The Commission has issued the enclosed Amendment Nos. 15 and 11 to Facility License Nos. DPR-29 and DPR-50 for Units 1 and 2 of the Grand Cities Nuclear Power Station. These amendments include Change No. 26 to the Technical Specifications and is in response to Commonwealth Edison's request dated December 15, 1974, as supplemented December 20, 1974; January 27, 1975; March 14 and 27, 1975, and April 9, 1975. These amendments also include your request dated May 15, 1974, as supplemented by filings dated October 22 and December 5, 1974.

These amendments (1) incorporate operating limits in the Technical Specifications based on the new General Electric Thermal Analysis Basis (GTAB), and (2) authorize changes to the APRM flux screen and APRM Rod Block Limits.

ATTACHMENT TO LICENSE AMENDMENT NOS. 11 AND 15
CHANGE NO. 26 TO THE TECHNICAL SPECIFICATIONS
FACILITY OPERATING LICENSE NOS. DPR-29 AND DPR-30
DOCKET NOS. 50-254 AND 50-265

Figure 2.1-2
 PEAK LHGR VERSUS CORE THERMAL POWER
 FOR A LIMITING TOTAL PEAKING FACTOR

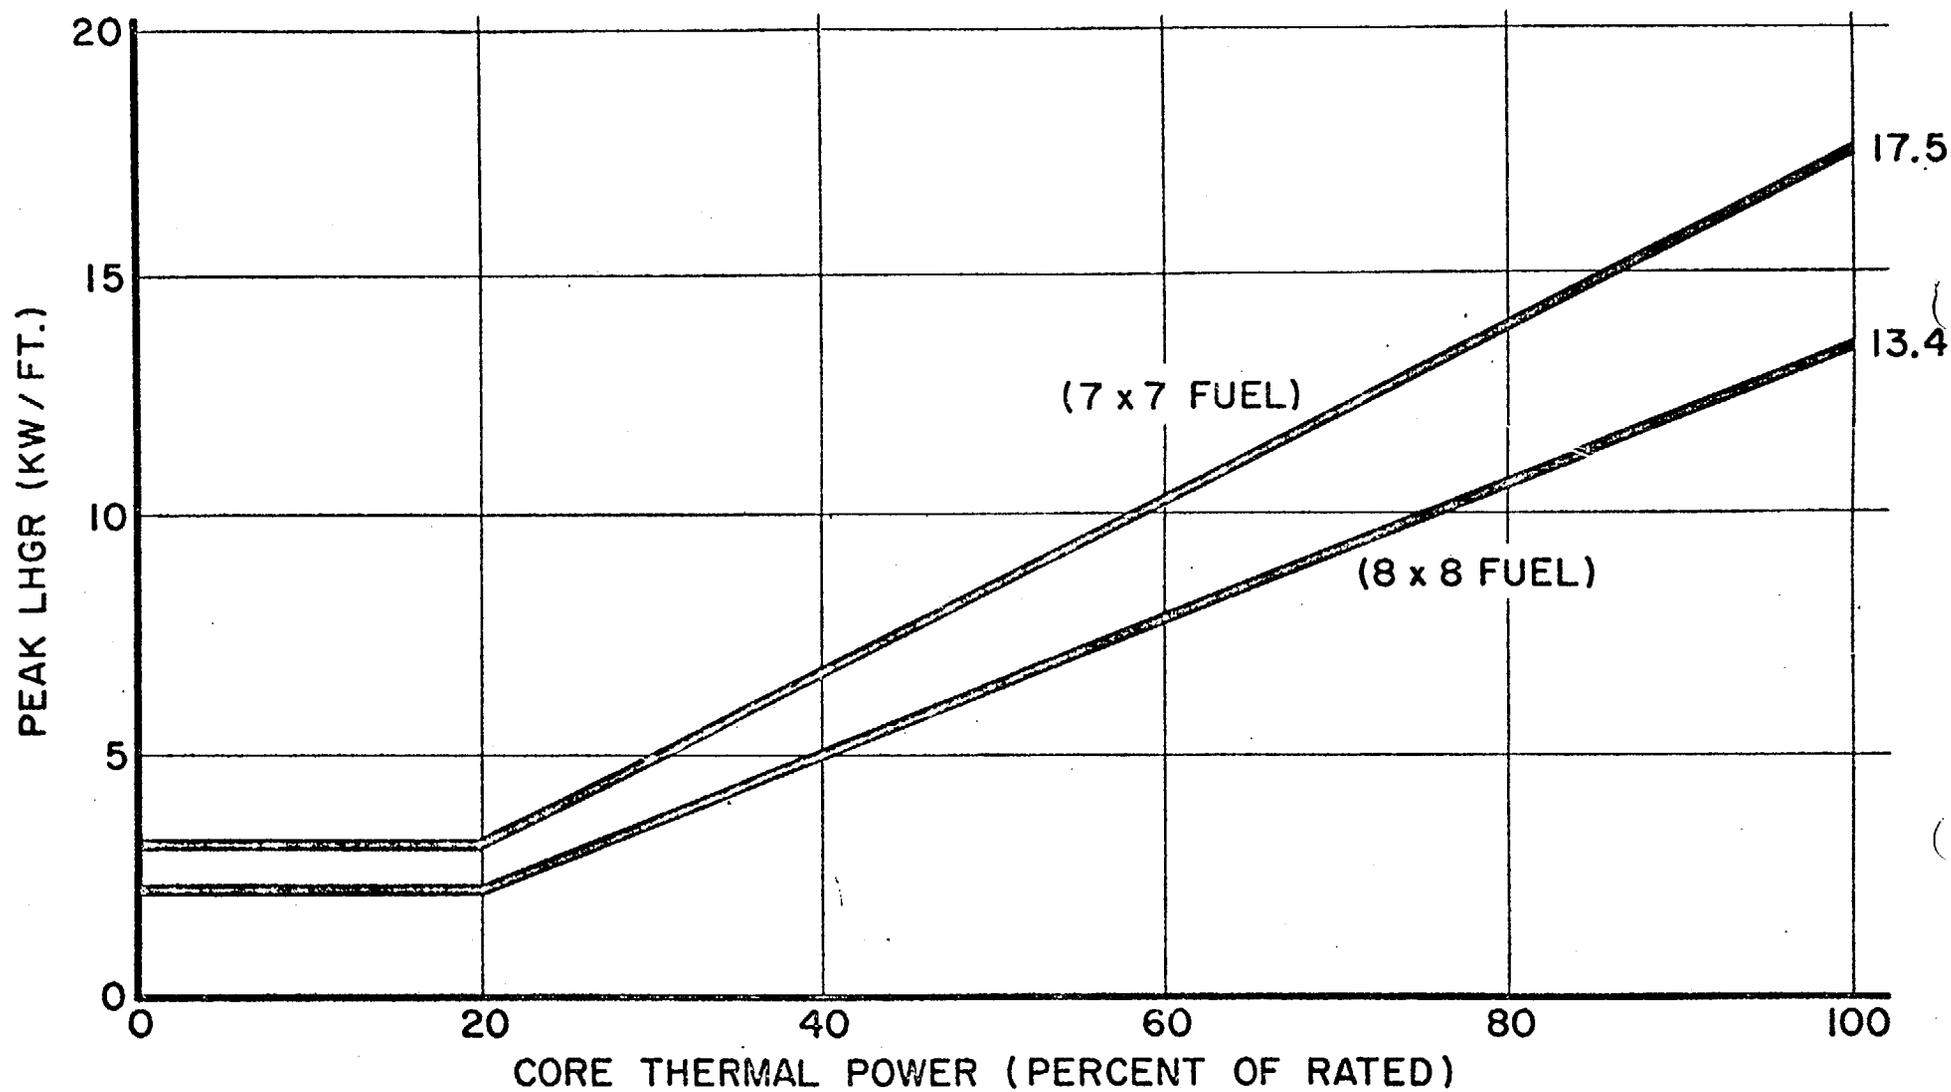
terms of heat flux and base the required settings on the design linear heat generation rates of 17.5 and 13.4 kw/ft for 7 x 7 and 8 x 8 fuel respectively. Figure 2.1.2 would be changed from a linear plot of peak heat flux versus power to a plot of peak LHGR versus power for 7 x 7 and for 8 x 8 fuel. For power levels between zero and 20% of rated core thermal power, peak LHGR rates of 3.5 and 2.68 kw/ft rather than total peaking factors are specified for 7 x 7 and for 8 x 8 fuel respectively. Below these LHGR levels fuel cladding damage because of a departure from nucleate boiling would not be expected and therefore these limiting safety system settings are acceptable.

TFP = LTPF unless the combination of power and peak LHGR is above the curve in Figure 2.1-2 at which point the actual peaking factor value shall be used.

AVERAGE PLANAR EXPOSURE - MWD/TON
FIGURE 3.5.1 MAXIMUM ALLOWABLE PLANAR LHGR
APPLICABLE TO QUAD-CITIES INITIAL AND RELOAD FUEL

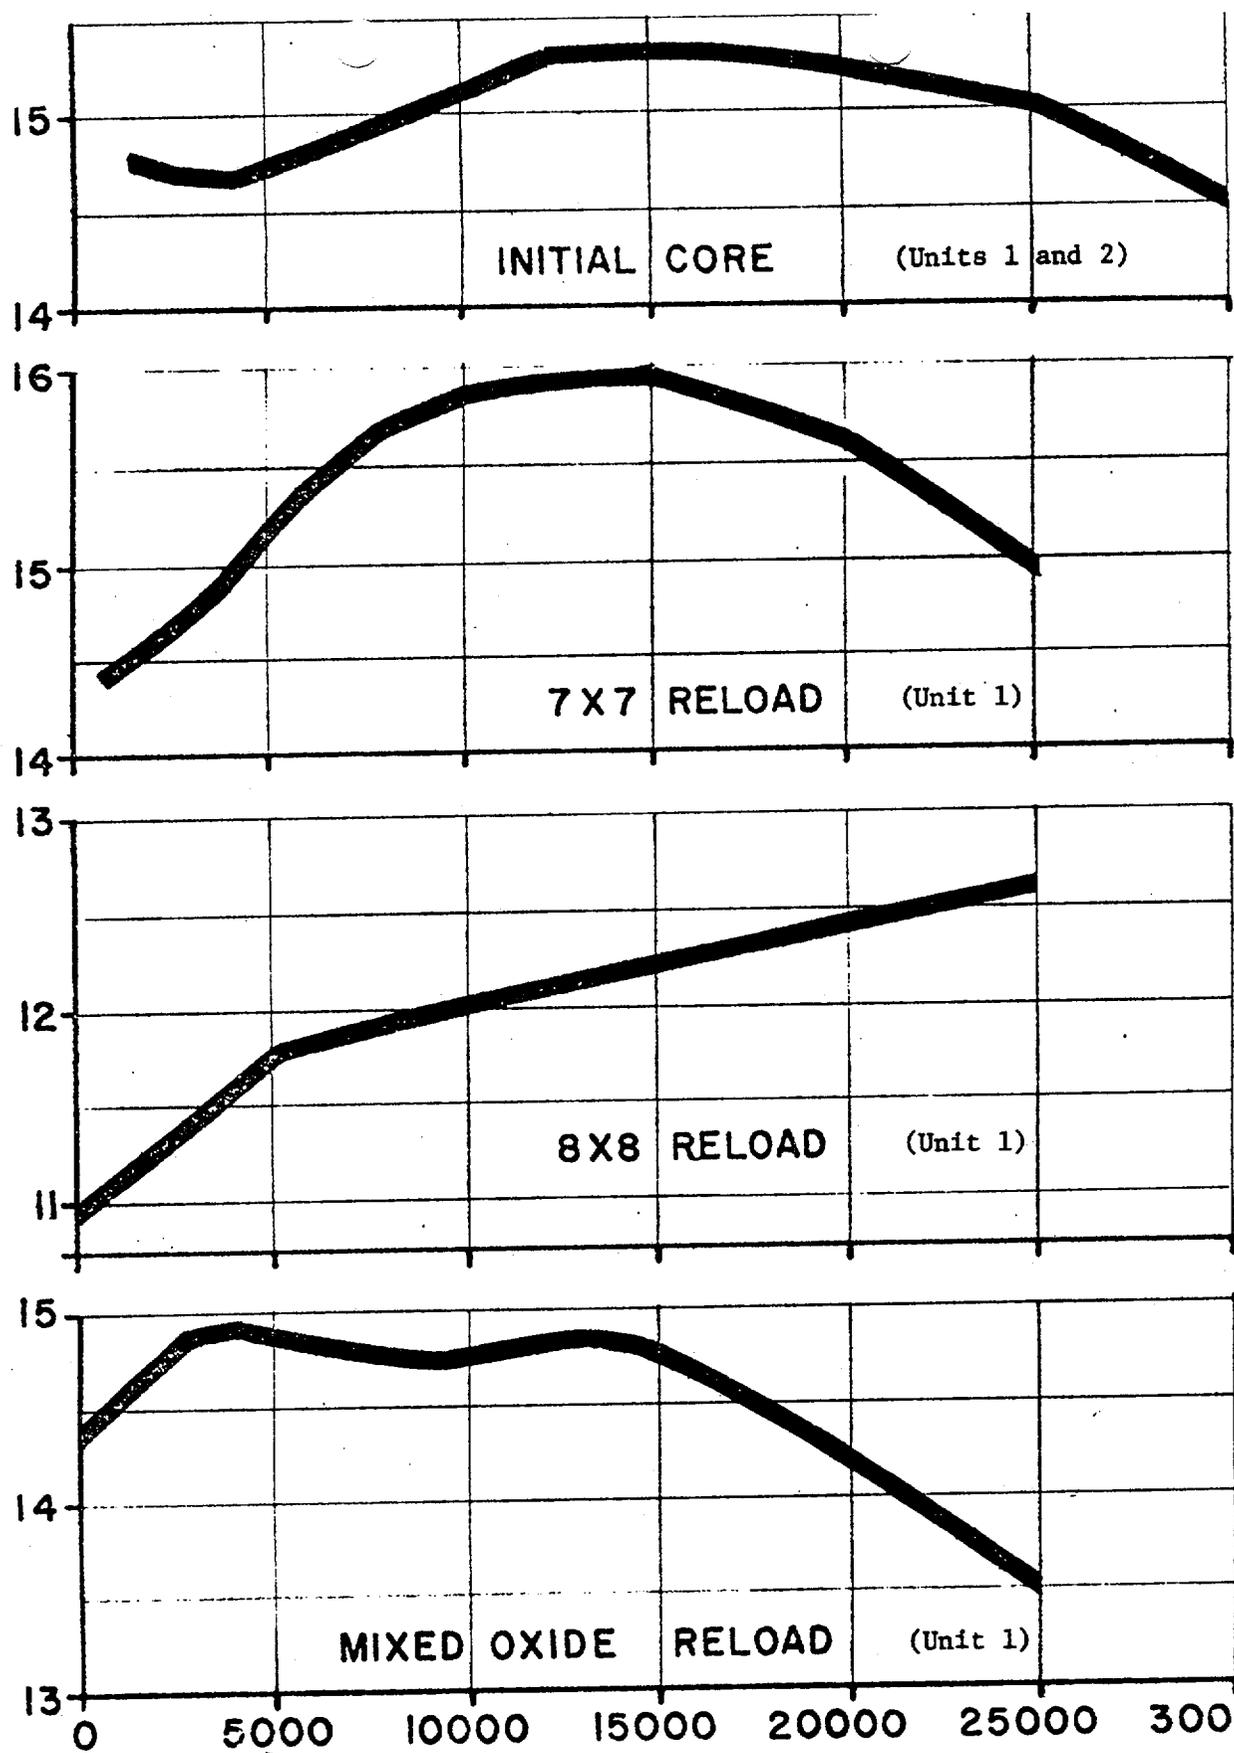
The maximum average planar LHGRs shown in Figure 3.5.1 are based on calculations employing the models described in Reference 1 as modified by Reference 2, and authorized in Reference 3.

FIGURE 3.5-2 K_f FACTOR

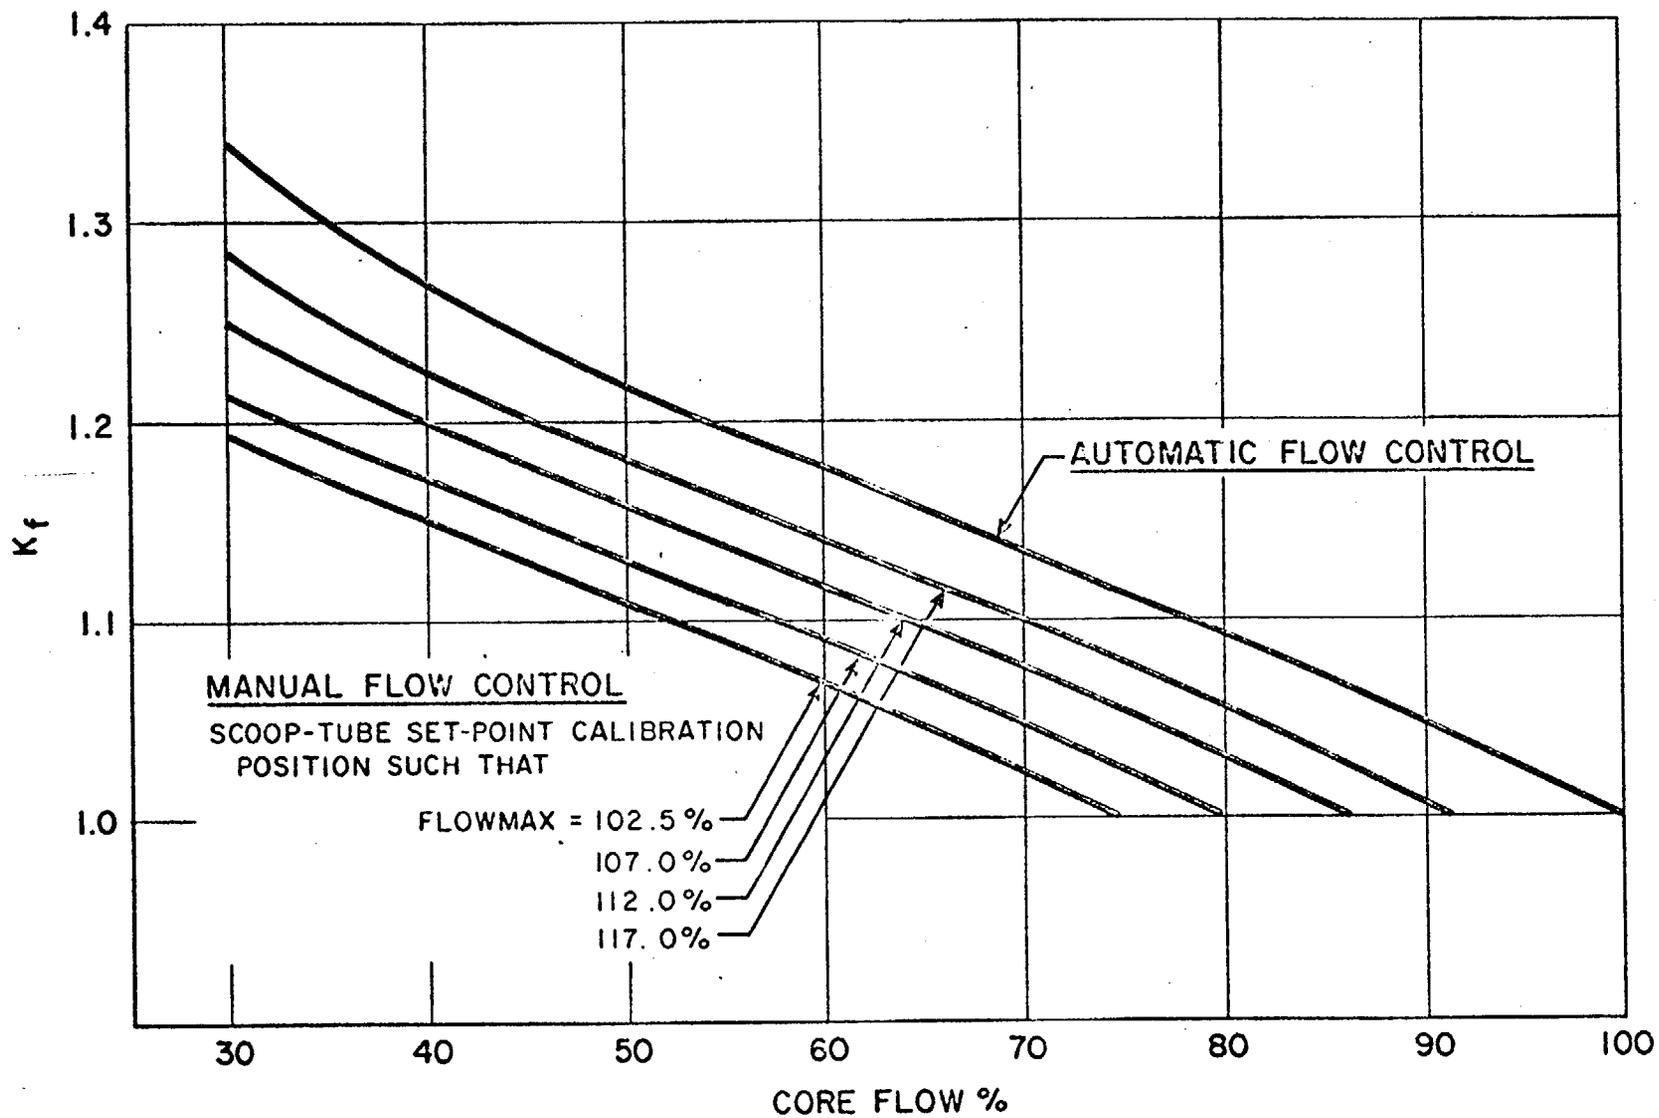
at rated power and flow. For core flows other than rated, these nominal values of MCPR shall be increased by a factor of K_f , where K_f is as shown in Figure 3.5-2.
